# Notice

### Information request

Our reference: EPML00853413

The application reference number is: A-PRCP-NEW-100779183

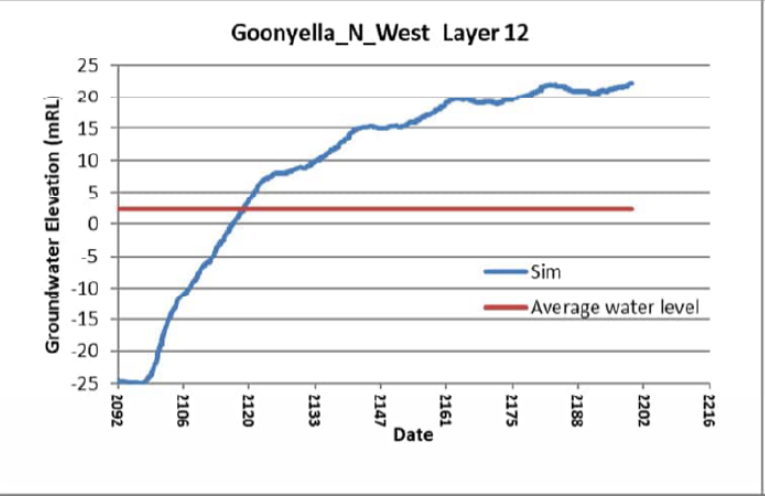
<p>Appendix D Hydrogeology, section 8.0 provides a summary of groundwater quality data across the project site collected through the existing groundwater monitoring network.</p> <p>Appendix D section 7.1 notes that there are 46 monitoring sites (it is assumed these are bores) but there is very little detail in regard to these bores. Additionally, of the 46 monitoring bores, hydrographs are presented for only 5 bores in section 7.3.</p> <p>A table should be included identifying each monitoring bore, its drilled date, ground elevation, depth, screened depth, geologic unit monitored and length of record available for water level and water quality data. This will provide a much clearer understanding of the groundwater monitoring data available to support the assessment.</p> <p>Understanding the data available from the monitoring bore network is important in understanding what data supports the groundwater assessment and modelling.</p> <p>Appropriate groundwater parameters and limits must be included in the PRCP schedule. Site-specific values based on site specific monitoring data are required to determine appropriate milestone criteria. This will help inform the schedule requirements to also reflect default WQOs and ANZG 2018 values which will be imposed as limits.</p> <p>Quality characteristics should be based on relevant contaminants of concern (CoC). CoC should be the same for surface water and groundwater and be based on mining process (dams and seepage) and waste characterisation.</p> <p>At least 8 data points are required to determine site-specific values in most cases. For groundwater, the 95th percentile of baseline (ideally pre mining) data can be used to determine site-specific limits for all indicators.</p>	<p>available for water level and water quality data,</p> <ul style="list-style-type: none"> <li>b) Additional hydrographs from existing monitoring bores, and</li> <li>c) Identification of the relevant contaminants of concern (CoC) for the site.</li> </ul>

<p>As per the Groundwater Guideline if there are less than 8 data points or the site-specific value is less than the default ANZG 2018 value, then the default guideline value is applied as a limit.</p> <p>See DES 2021 Groundwater Guideline - <a href="https://www.publications.qld.gov.au/dataset/groundwater-quality-assessment-guideline/resource/472cc88a-000a-4bb8-a60d-204cfe7e0238">https://www.publications.qld.gov.au/dataset/groundwater-quality-assessment-guideline/resource/472cc88a-000a-4bb8-a60d-204cfe7e0238</a></p>	
4	<b>Groundwater use, PRC plan section 1.2.5.5</b>	<p><b>Groundwater Dependent Ecosystems (GDEs)</b></p> <p>It is noted in section 1.2.5.5.that the Isaac River and its tributaries have terrestrial ecosystems present which are potentially facultative GDEs.</p> <p>However, the PRC plan does not identify these potential GDEs or outline how watercourse monitoring will be undertaken so that any impacts on GDEs resulting from post closure changes in water balance, surface water and groundwater interactions due to rehabilitated landform and NUMA.</p>	<p><b>Provide a revised PRC plan and Appendix G which -</b></p> <ul style="list-style-type: none"> <li>a) Identifies potential GDEs; and</li> <li>b) Commits to implement the necessary monitoring designed to detect change in GDE health resulting from post closure groundwater impacts due to final rehabilitated landform and NUMA.</li> </ul>

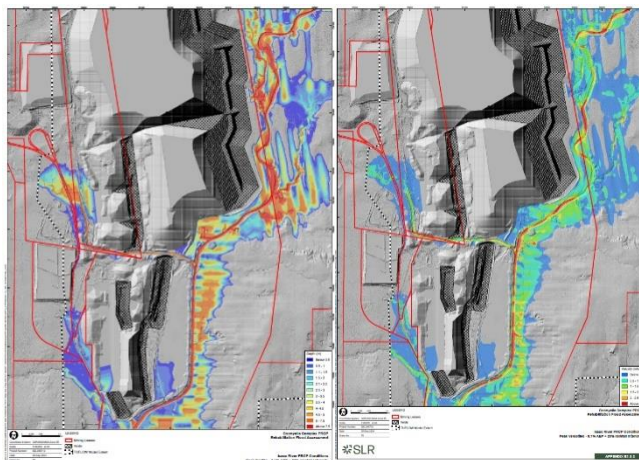
Figure 66 Water level change from the 2024 groundwater elevations post-closure.	<p>Figure 66 provides changes in surficial sediments water level from the initial 2024 levels at the end of 2199 in m.</p> <p>This figure is used in Section 15.8.2 to discuss potential impacts to GDE's.</p> <p>However, the change in water level contours are presented in 20 m intervals.</p> <p>Additional change in water level contours should be provided for the area around the mined area and at 1 m contour interval to more clearly understand impacts in the surficial sediments adjacent the mine leases.</p>	Additional change in water level contours in the surficial sediments, for the area around the mine leases at 1 m contour intervals.
12	<p><b>Appendix D, section 15.5</b></p> <p>Figure 47 Groundwater elevations at start of P1 and water level change end of P3 and P4 (in m)in Model Layer 10 GMS</p>	<p><b>Predicted long term groundwater flow</b></p> <p>Figure 47 shows change in water level contours at the end of P4 (year 2199) layer 10, GMS (Goonyella Middle seam).</p> <p>These contours demonstrate a long-term drawdown of 100 m extending off to the north-east of Redhill Mine, extending to what appears to be the model boundary in that direction.</p> <p>However, in the report there appears to be no predicted long term groundwater elevation contours provided for the Goonyella Middle seam which captures the full Redhill Mine area and the model area to the north-east.</p> <p>These contours are required to demonstrate the predicted long term groundwater flow direction around all parts of the Redhill Mine and its connection with the Goonyella Riverside residual voids and underground mines post mining.</p>	<p><b>Provide a revised Appendix D inclusive of -</b></p> <p>Predicted post mining equilibrium groundwater elevation contours for layer 10, Goonyella Middle Seam which demonstrate predicted groundwater flow direction from all areas of proposed mining in the Red Hill mine and Goonyella Riverside mine areas.</p>

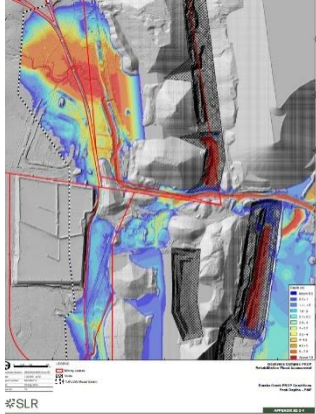
13	<p><b>Appendix O Void closure plan</b></p>	<p><b>Goonyella residual void modelled depth and average water level</b></p> <p>Appendix O appears to provide no detailed information about the elevation of the base of the Goonyella residual void used in determining the modelled average void water levels.</p>	<p><b>Provide a revised Appendix O inclusive of -</b></p> <p>a) Clarification if the modelling of Goonyella residual void with a uniform base is</p>

<p>In Appendix D, Section 15.4.2.6, in relation to Goonyella residual void northern section initially, and then the middle section of the void, it states:</p> <p><i>'Note: The pit floor is some -35 mAHD at this location, the pit floor adopted in the residual void (surface water) water balance model is set at a uniform -45 mAHD (it is assumed that the specialist modellers used the deepest pit floor elevation in their water balance model).'</i></p> <p>This results in the water level dip or decrease at the start of the water level hydrographs when the groundwater model drain cells (at bottom of pit) are changed to CHD and adopt the predicted water balance model pit water levels (Section 15.4.1). This dip in the water level hydrographs is recognised in all of the hypothetical observation point hydrographs. This is particularly evident in the middle set of hydrographs where the Goonyella open cut mine only extends to a depth of around 25 mAHD in this area (mining is shallower in this area due to environmental constraints in this area).</p> <p>It appears then that the Goonyella residual void has been modelled in Appendix O as having a uniform void base of -45 m AHD when in places it will be higher than this and in the middle as high as +25 m AHD.</p> <p>It is not clear how this has impacted the modelled void water level? Is it possible that by using a deeper base for the void, than actually will exist, the modelled void water level is lower than that which will actually result.</p> <p>The PRC plan section 4.3 states that Goonyella void will be partially backfilled at the northern end, it is not clear if the above modelling has considered the void base after the intended backfill level.</p>	<p>considerate of proposed backfill of the void at the northern end; and</p> <p>b) Information on how the modelling of Goonyella residual void with a uniform base of -45 m AHD may impact the modelled average void water level and the void behaviour predictions as a sink.</p>

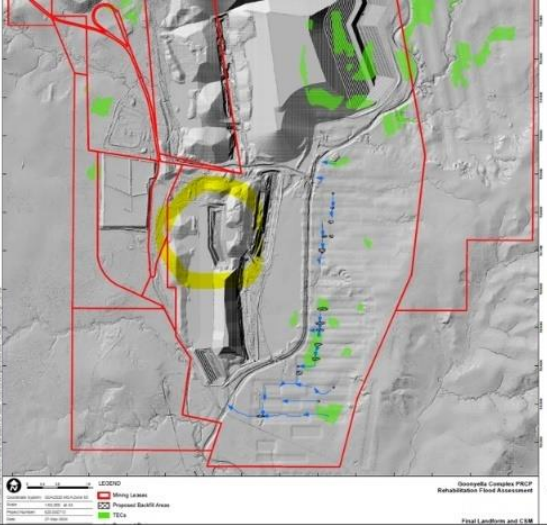
<p>The PRC plan in sections 1.4.4 and 1.4.5 provides information on progressive rehabilitation since the commencement of the operation (1990).</p> <p>The PRC plan Table 19 provides a summary of progressive rehabilitation until 2059. It is noted that PRC plan states the life of mine for GRM as 2059 but some components of GRM will not be rehabilitated or surrendered at 2059 due to connecting operation of RHM.</p> <p>The PRCP schedule shows progressive rehabilitation planned till approximately 2137 and beyond for some areas, which is not reflected in PRC plan Table 19.</p> <p>As such, further information is needed to understand rehabilitation planning until surrender (likely to be at closure of RHM (2094)).</p> <p><u>Area available for rehabilitation</u></p> <p>The PRC plan in section 1.4.5 provides an explanation that spoil dump areas which cover almost 30% of the disturbance area are planned to achieve rehabilitation milestones up to 'Revegetation' by 2059 and rest of the milestones are scheduled for completion beyond the RHM mine life. The overall rationale for the delay is the mining and dumping sequence.</p> <p>Similarly, areas impacted by subsidence are proposed to be unavailable for progressive rehabilitation up until the flooding of underground areas occurs, which is predicted to be in 2061 as per the PRCP schedule.</p> <p>Progressive rehabilitation of infrastructure areas is delayed with a similar rationale, on the basis that the area will not be available while being utilised for for RHM.</p> <p>The PRCP guideline section 4.1, step 3 determines that land is available for rehabilitation unless that land is being used for</p>	<p>a) A discussion of rehabilitation timing that proposes accelerated scheduling of progressive rehabilitation until surrender ( compared to the current proposed timeframe) which nominates rehabilitation as soon as areas become available in accordance with the definition of available land under the PRCP guideline; and</p> <p>b) A revised Table 19, and PRCP schedule to reflect earlier timeframes of progressive rehabilitation for spoil dumps and subsidence.</p>

<p>operating infrastructure, contains permanent infrastructure, or has a probable or proved ore reserve to be mined in 10 years, or the land is required for mining the proved ore reserve.</p> <p>The justification provided by in the PRCP for the spoil dump and subsidence domains being unavailable for progressive rehabilitation does not meet the PRCP guideline requirement.</p> <p>A revised mining and dumping sequence should be developed and discussed in the PRC plan to allow the timing of rehabilitation for the spoil dump to be accelerated. Further, the timing of subsidence rehabilitation should be reviewed, and the PRC plan should discuss opportunities to accelerate progressive rehabilitation.</p> <p>In the PRCP Schedule, the rehabilitation areas should be revised to represent earlier progressive rehabilitation.</p>	
25	PRC plan s1.4.4	<p><b>Existing Rehabilitation</b></p> <p>The PRC plan in Table 18 and section 1.4.4 indicates that progressive rehabilitation commenced in 1990. However, it is not clear from the information provide when any of the rehabilitation works were completed. Other details about the existing rehabilitation areas are limited, and further information is required to understand the current condition of these areas. This information is important to ensure that any maintenance or repairs of existing rehabilitation are adequately captured by the PRCP.</p>	<p><b>Provide a revised PRC plan section 1.4.4 to:</b></p> <ul style="list-style-type: none"> <li>a) Clarify the ,mine domains that are included in the existing rehabilitation area,</li> <li>b) Discuss the relevancy of RM2 (Remediation) to existing rehabilitation areas,</li> <li>c) Include an approximate timeline of when each rehabilitation activity was commenced and completed for the existing rehabilitation area that corresponds to the proposed rehabilitation milestone,</li> <li>d) Clarify the current status of existing rehabilitation in terms of meeting</li> </ul>

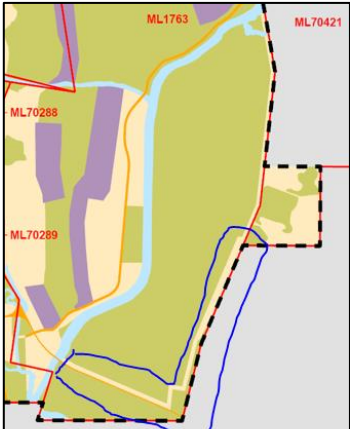
50	<b>PRC Plan section 3.1.1 and Figure 28 Final site design</b>	<p><b>Grazing PMLU</b></p> <p>The figure shows thin sections of grazing PMLU bisecting Woodland PMLU, exposing the rehabilitating woodland to potential impacts such as weed spread.</p> <p>It is unclear if the woodland PMLU will be grazed. The thin sections of grazing poses a risk to achievement of self-sustaining, stable woodland PMLU, due to use of introduced</p>	<p><b>Provide a revised PRC plan inclusive of -</b></p> <ul style="list-style-type: none"> <li>a) Explain why the thin fringing of grazing section that bisect woodland PMLU is required; and</li> <li>b) Reconfigured final design to change PMLU of the abovementioned thin sections to woodland PMLU.</li> </ul>

<p>pasture species in revegetation which likely to spread and take over the woodland habitat PMLU unless there's an effective barrier in place.</p>  <p><i>Figure 1: The thin strip of grazing PMLU going through the woodland habitat</i></p>	
<b>Rehabilitation trials</b>			
51	PRC plan section 6.1.4.2	<p><b>Permian spoil use as growth media</b></p> <p>There are no rehabilitation trials proposed at GRM.</p> <p>The section 6.1.4.2 states that for the woodland habitat PMLU, an alternative growth media may be used prepared by ameliorating suitable permian spoil. There is no information provided to demonstrate reliability of proposed rehabilitation approach of use of permian spoil as a primary growth media in absence of topsoil coupled with low vegetation in achieving long term rehabilitation success.</p> <p>Confirm if above rehabilitation approach of use of permian spoil as primary growth media has been adopted at GRM for any</p>	<p><b>Provide a revised PRC plan inclusive of –</b></p> <ul style="list-style-type: none"> <li>a) Area details (area in hectares, and break up per domain) that is proposed to use permian spoil as primary growth media; and</li> <li>b) Details of existing rehabilitation on site that demonstrate successful use of permian spoil as primary growth media for rehabilitation and able to support growth of vegetation long term.</li> </ul>
